Frame (Defect Inspection) REPORT (hereinafter called the "Report")

Report Number 00024 Time:11:30 AM

Inspection Date: 17/03/2022

Property Address: LOT sample

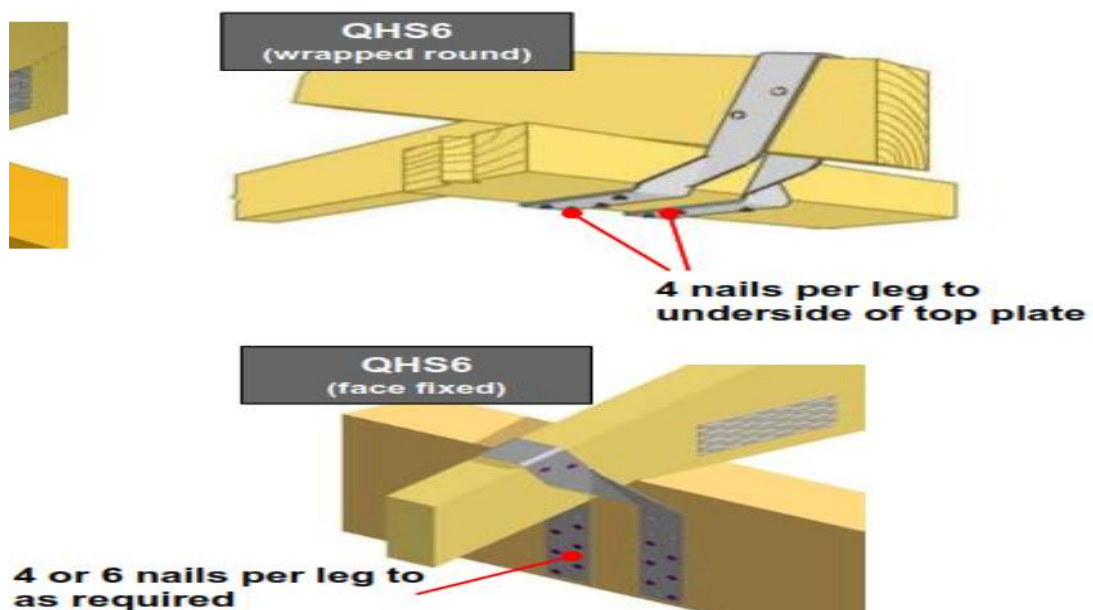
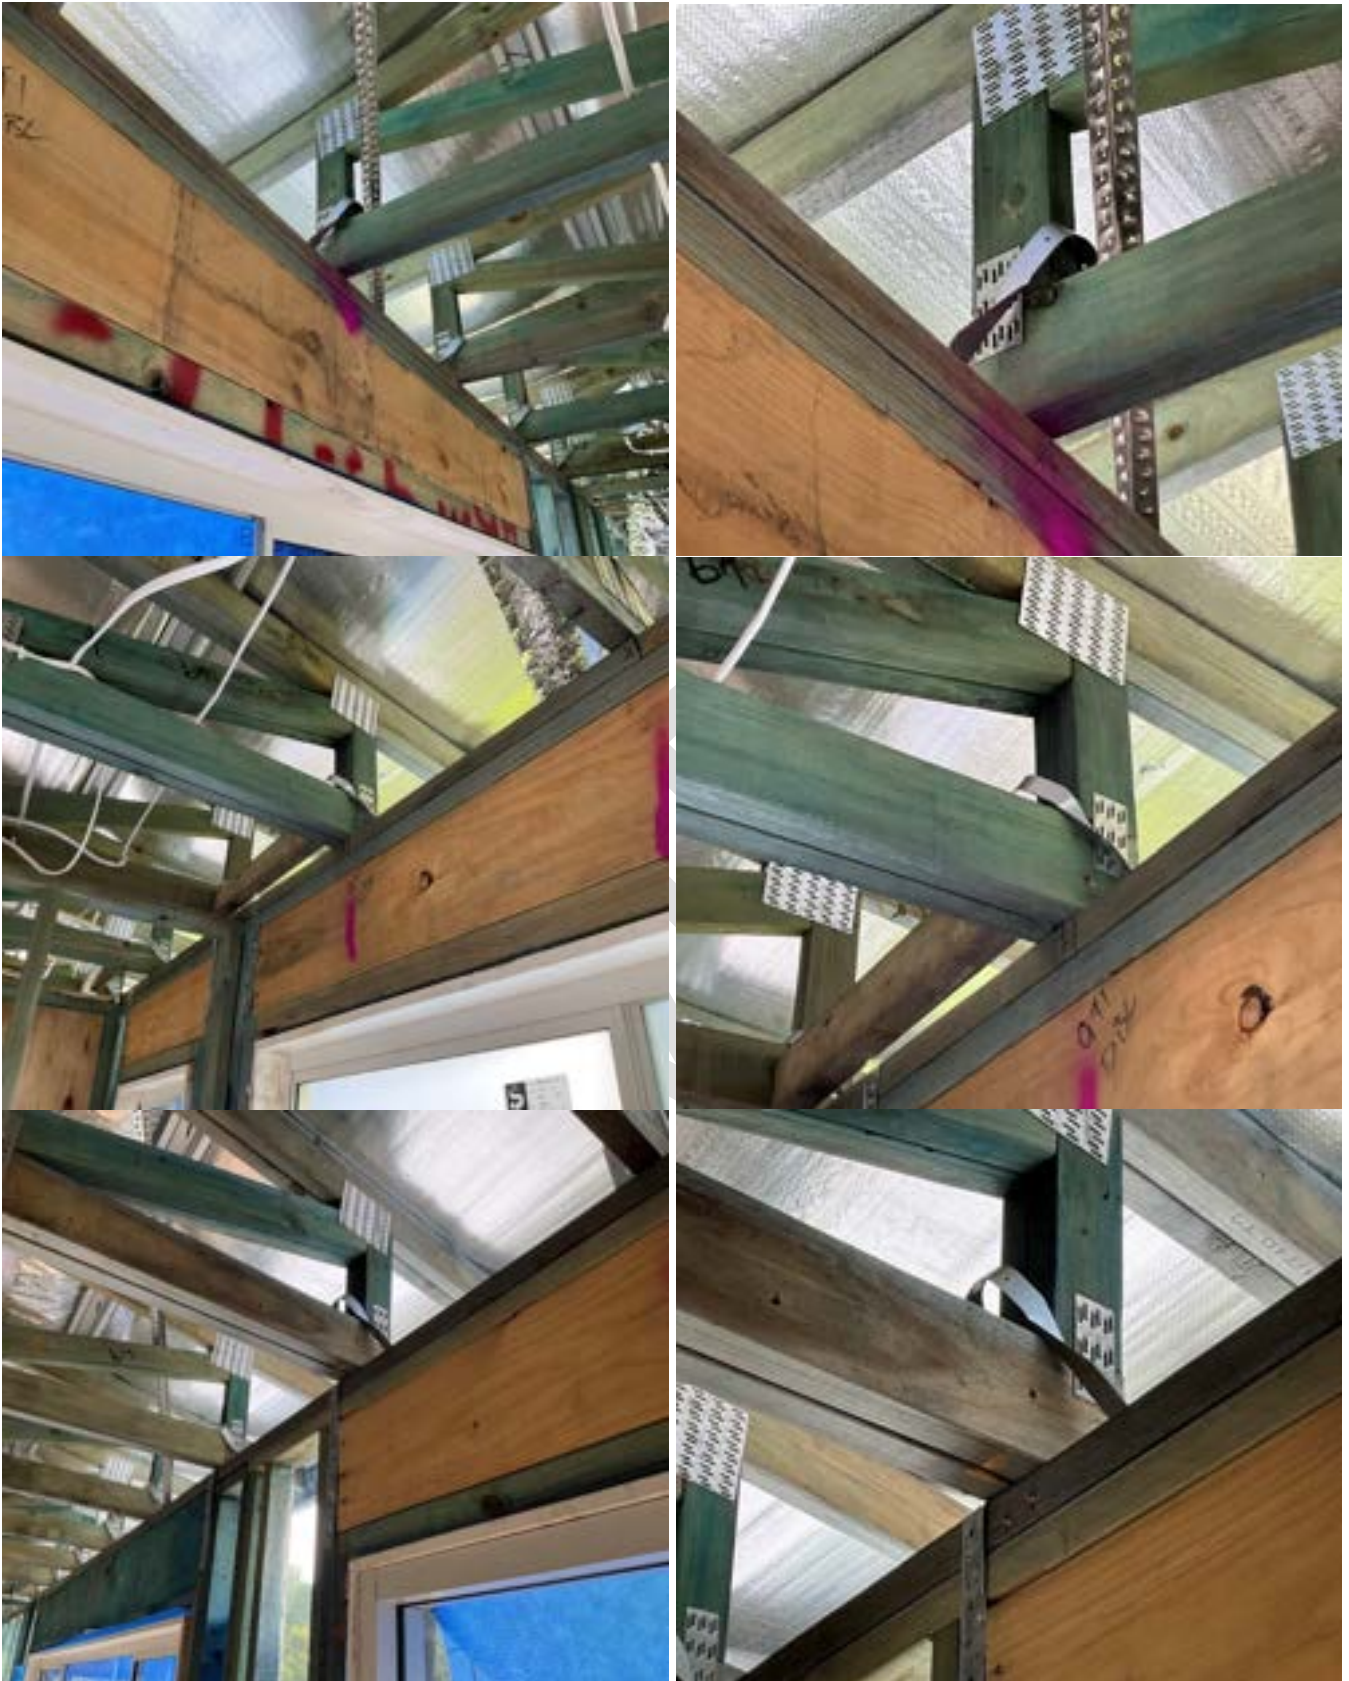
30. The flooring has been damaged and has large gaps, this will need rework, not in an appropriate, skilful way or with reasonable care and skill.

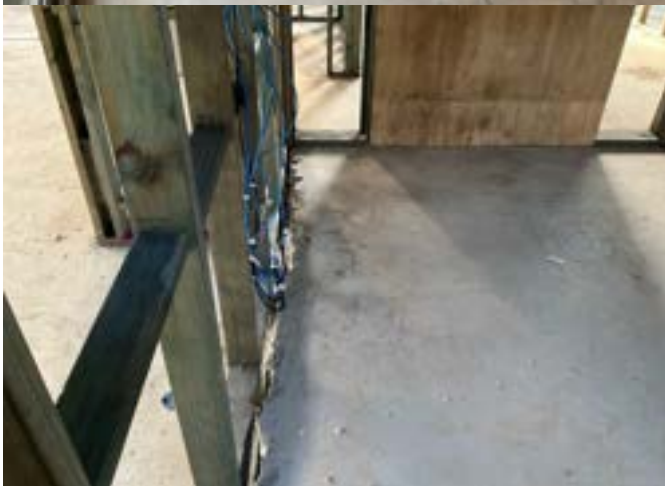
34. There is a laminated beam that has been left out in the weather and is starting to delaminate, owner has advised that these have previously been replaced due to weather damage, this will need rework, not in an appropriate, skilful way or with reasonable care and skill.
